APPLICATION NO.	FILING DATE	FIRST NAMED INVENTOR	ATTORNEY DOCKET NO.	CONFIRMATION NO.
10/575,052	04/02/2007	Malcolm Lambert	DP-310801	9228
22851 7590 07/01/2010 DELPHI TECHNOLOGIES, INC M/C 480-410-202 PO BOX 5052 TROY, MI 48007				
EXAMINER				
JONATIS, JUSTIN M				
ART UNIT		PAPER NUMBER		
3752				
MAIL DATE		DELIVERY MODE		
07/01/2010		PAPER

Office Action Summary

DETAILED ACTION***Claim Rejections - 35 USC § 102***

U.S. Patent #1,952,816 to Mock: Figure 3

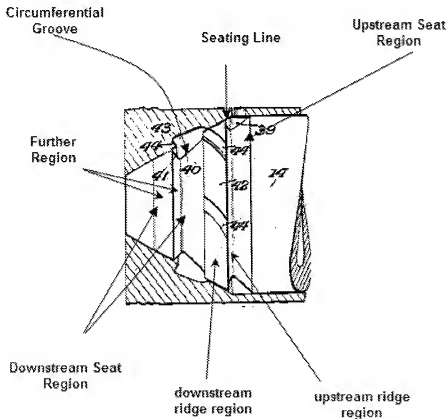
The figure below is reproduced from the Mock Figure 3 reference in order to show examiner's interpretation.

Mock discloses an injection nozzle for an internal combustion engine which is a valve covering orifice type injector, the injection nozzle comprising: a nozzle body (casing member (6)) provided with a bore (bore (10)) defining a valve seating surface (conical valve seat (11)), a valve member (valve (14)) which is moveable within the bore, wherein the valve member includes an upstream seat region (See Figure above) defining an upstream cone angle, where the upstream cone angle and the seat cone angle define an upstream differential angle, and a downstream seat region (See Figure above) defining a downstream cone angle, the downstream cone angle and the seat cone angle together defining a downstream differential angle, the valve member further comprising an annular ridge (See Figure above, downstream ridge region and upstream ridge region) protruding from the upstream and downstream seat region being disposed immediately downstream of the upstream seat region, wherein the protruding annular ridge defines a seating line (See Figure above) having a seat diameter, the seating line and being engageable with the valve seating surface to control fuel injection from the nozzle body. The protruding annular ridge includes an upstream and downstream ridge region (See Figure above) where the seating line is defined at an intersection between the upstream and downstream ridge regions.

The valve member disclosed by mock further includes a circumferential groove (See Figure above) arranged downstream of the downstream ridge region and immediately upstream of the further region (the end portion of the downstream seat region), wherein a lower edge of the circumferential groove and the further region define an intersection which defines, together with the seating surface a radial clearance that is sufficiently small so that a lower portion of the downstream ridge region defines a load bearing surface for the valve member.

7. Examiner agrees with applicant's interpretation of figure 3, however does not agree that the claimed limitations have not been met by the invention described by Mock. The zoomed in view of Figure 3 clearly shows that the angle of the bore in the casing is wider than the cone angle of the conical shoulder, as seen in the magnified view of figure 3 provided by applicant, however in the same figure it can be seen that the angles converge downstream of the gap creating a seat region. Therefore since the downstream region of the shoulder and the casing are in contact the limitations of an upstream seat region have been met.

9. Examiner disagrees. Applicant has not claimed that the upstream seating region must shut off the flow of fuel. Applicant has merely claimed that the valve member has an upstream seat region. Because mock shows a region upstream from the tip of the needle that sits against the casing (6) this limitation is fulfilled. Further applicant acknowledges in the remarks and arguments that on page 2, lines 131-137 of mock, "the frusto-conical shoulder (42) is preferably provided with spiral slots or grooves (44) on its periphery for increasing the area on which pressure may act to move valve (14)..." It's unclear how this structure does not assist in controlling fuel injection from the nozzle body as it clearly is aids in allowing the valve needle to move.

12. The emphasized portions of the text show that the clearance (46) is a strictly present in the embodiment illustrated by figure 4 and was incorporated (along with the features of figure 3) into the embodiment illustrated in figure 5. This further provides evidence that the embodiment in figure 3 does not have a clearance between the casing and the frusto-conical shoulder. Therefore the rejection of independent claim 1 is maintained. Because the arguments of claims 2-12 are dependent on claim 1 and no further arguments have been presented, the rejection of claims 2-12 is also maintained.
